Staff Report

Knoxville Historic Zoning Commission

File Number: 10-F-23-HZ

Location: 1800 Clinch Ave. **Parcel ID** 94 N J 010
District: Ft. Sanders NC
Zoning: O (Office)
Description: American Four Square, c.1915
Two-and-one-half-story residence with a hipped roof clad in asphalt shingles, a brick exterior, and a continuous brick foundation. Hipped roof centered on façade.

APPROVED FRONT ELEVATION WINDOWS

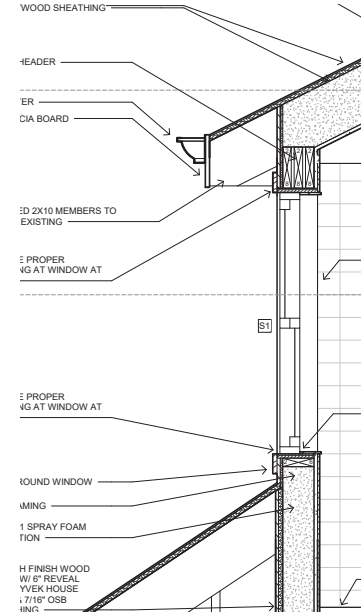
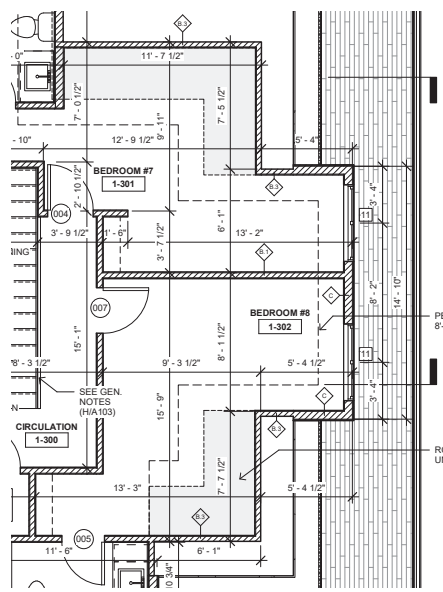
- On the center bays of the second story, glass block windows were installed instead of one-over-one, double-hung windows as proposed. The glass block windows also appear to be extended in height from the drawings, with the bottoms of the windows resting on the porch roof instead of separated by sills and 1-2 courses of brick as shown.

3. Second-story center windows: the glass block windows and window size is inappropriate for the building's design and does not reflect the approved COA. The initial staff recommendation, and Commission discussion, noted that the applicant should select double-hung, one-over-one windows and revise the window heights to reflect the initial approval, be the same overall size and placement as the windows on the second-story outer bays, and include sills as initially submitted.

The application proposes installing "tint coated" double-hung windows in front of the glass block windows, to retain the fire protection of glass block but meet the design guidelines which recommend double-hung windows be used. The applicant should submit additional details on the "tint coat," and a section showing the double-hung windows' installation within the

Provided the framing and panes of the additional double-hung window are aligned in plane with the adjacent second-story windows, this may be an appropriate solution. If they are flush or project outward from the building elevation, the applicant should remove the glass block and install double-hung windows as initially proposed instead.

Regarding the second-story center windows: the applicant should either a) submit documentation showing the exterior windows to be installed as aligned in plane with the adjacent second-story windows or b) select double-hung windows to replace the glass block infill, revising the fenestration opening to match the original COA and the size of adjacent windows, with a revised drawing submitted to staff for approval. Staff recommends denial of the installed slider windows in the dormer and the installation of double-hung windows as proposed, with a revision drawing to be submitted to staff.

Compliance Plan:

1. Raise window sill to align with adjacent windows.
2. Install concrete window sills to match adjacent windows.
3. Install double-hung windows with a tint coat in-front of the glass masonry fire protection in the openings. This will provide visual covering from the glass masonry while still allowing for natural light inside the space.

The grid of the glass masonry will be interior of the windows and be no more visible than curtains or blinds.
